MIL-R-23016(WEP)  
 Amendment 3  
15 December 1964  
 Superseding  
 Amendment 2  
 15 March 1963

## MILITARY SPECIFICATION

## RADIO SET AN/ARC-94

This amendment forms a part of Military Specification MIL-R-23016(WEP) dated 16 October 1961 and has been approved by the Bureau of Naval Weapons, Department of the Navy.

TYPES II or III REC/TRANS.  
FIGURE 35

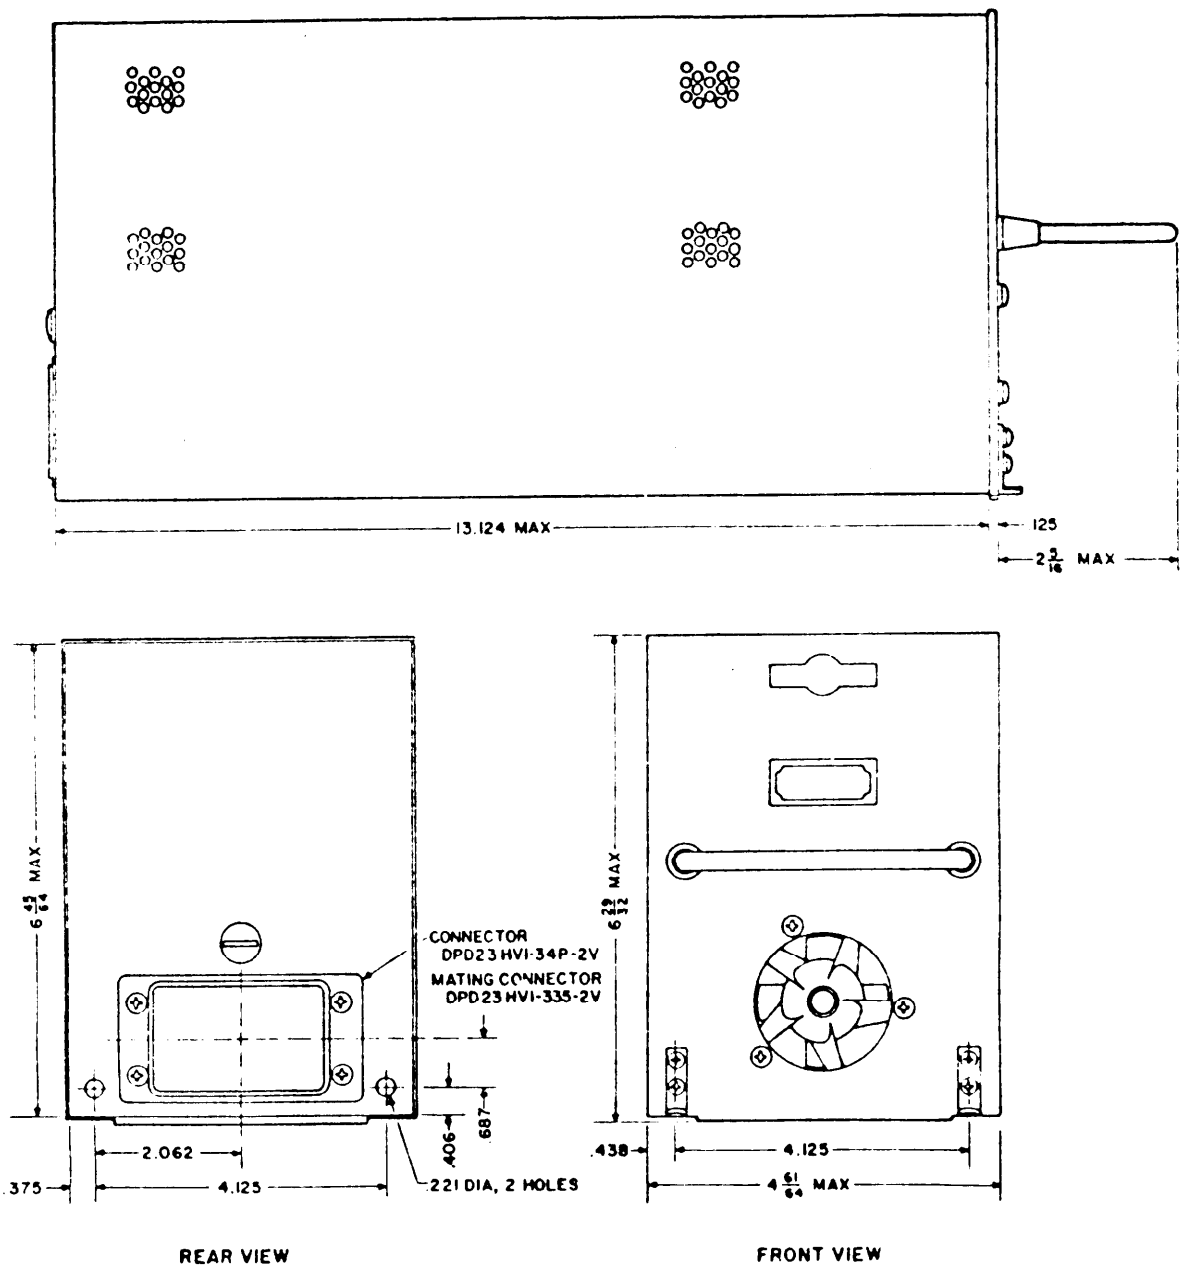
\*Page 116, Delete Figure 33 and substitute the following new Figures:

"Figure 33	Transmissibility vs Frequency -- Types I and IV
Figure 34	Type II Receiver Transmitter
Figure 35	Type II or III Receiver Transmitter
Figure 36	Transmissibility vs Frequency -- Retrofit in a MT-1415/ARC-38 - Types II or III
Figure 37	Type II Power Supply"

The 350S-1, 350S-3 and MT-1415/ARC-38 are produced with either a rectangular cut-out (not shown) or oval cut-outs as shown. Trays with rectangular cut-outs allow discharge of the exhaust air for proper operation of the Type II or III Rec.-Transmitter. The Type II or III units will operate on a reduced rating when adapted to mounts having oval cut-outs. The manufacturer strongly recommends that the (4) holes "AA" be punched in the positions shown using a 1-1/2 diameter Greenlee punch or equivalent for increased performance and maximum reliability of the Type II or III units. The cup portion of the Greenlee punch should be placed on the top side of the mount floor to avoid distorting the tray during punching operation.

1. Clearance for sway movement of unit on vibration mount equals 1/2 inch on all side.
2. Pendant cable as shown is part of **Type III retrofit adapter only**. The **Type II retrofit adapter does not have pendant cable**.

FREQUENCY CPS  
TRANSMISSIBILITY VS FREQUENCY  
TYPE II & III RETROFIT IN A MT1415/ARC-38

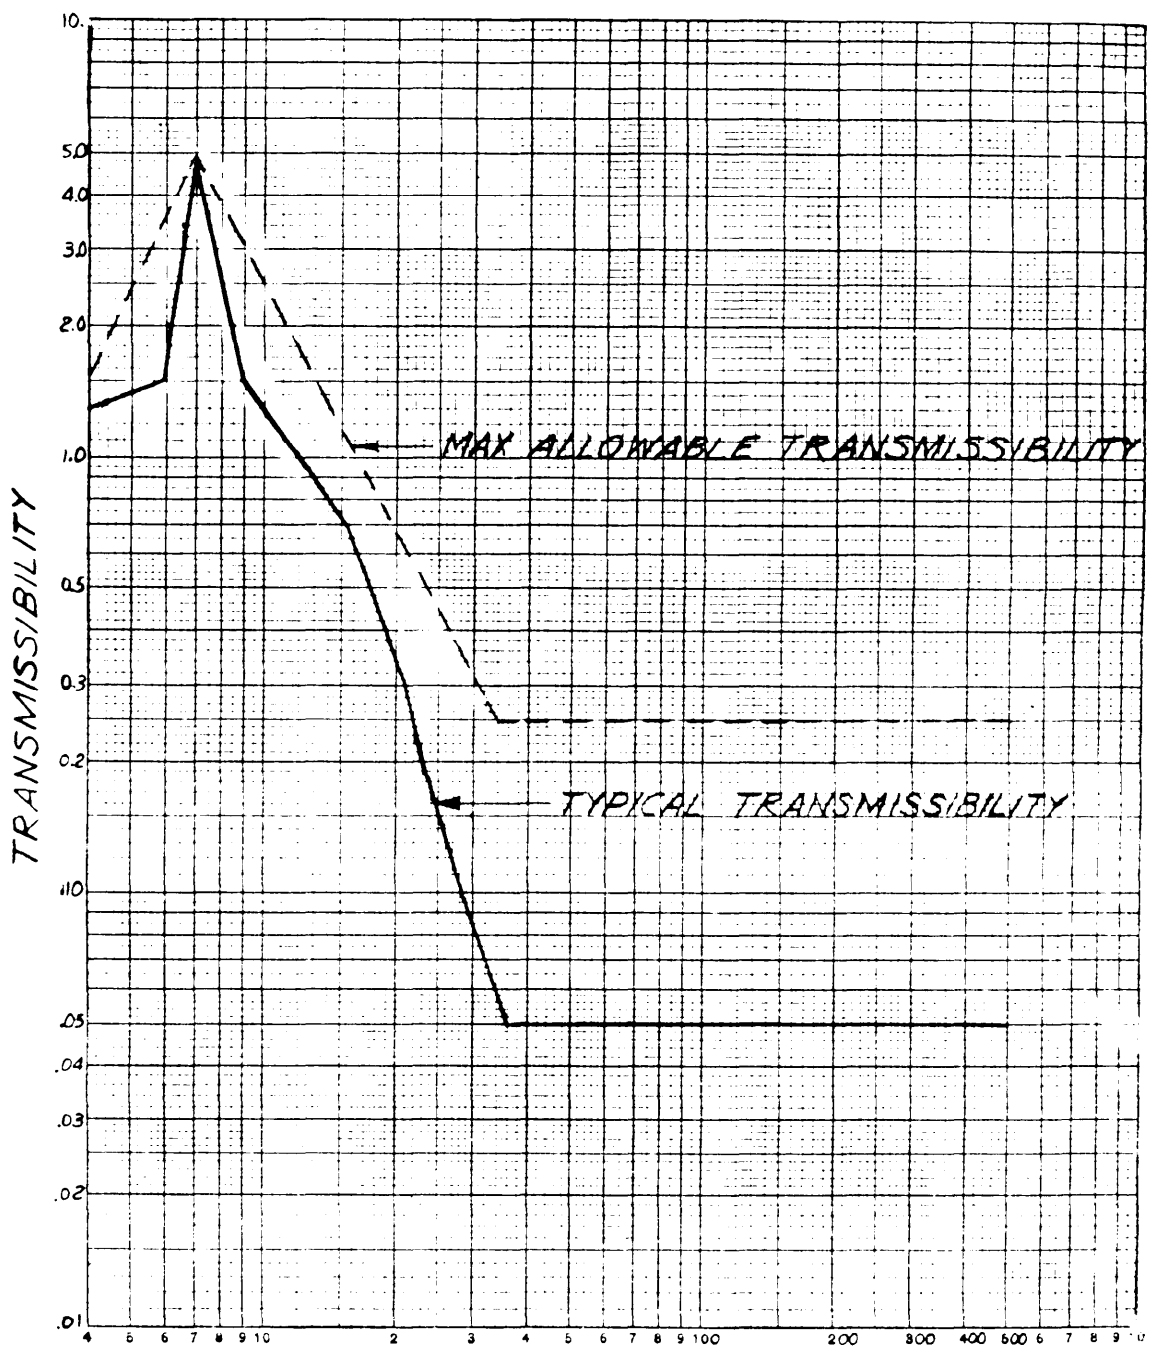
"3.3.4.3.1 Function: The Type I and Type IV equipment mounting, MT-2641/ARC-94, shall have the transmissibility shown in Figure 33 to allow the equipment to perform under the specified environmental requirements. The Type II and Type III equipment retrofit adapter mounts, MX (\*)/ARC-(\*) and MX (\*)/ARC-(\*), shall have the transmissibility shown in Figure 36 to allow the equipment to perform under the specified environmental requirements."
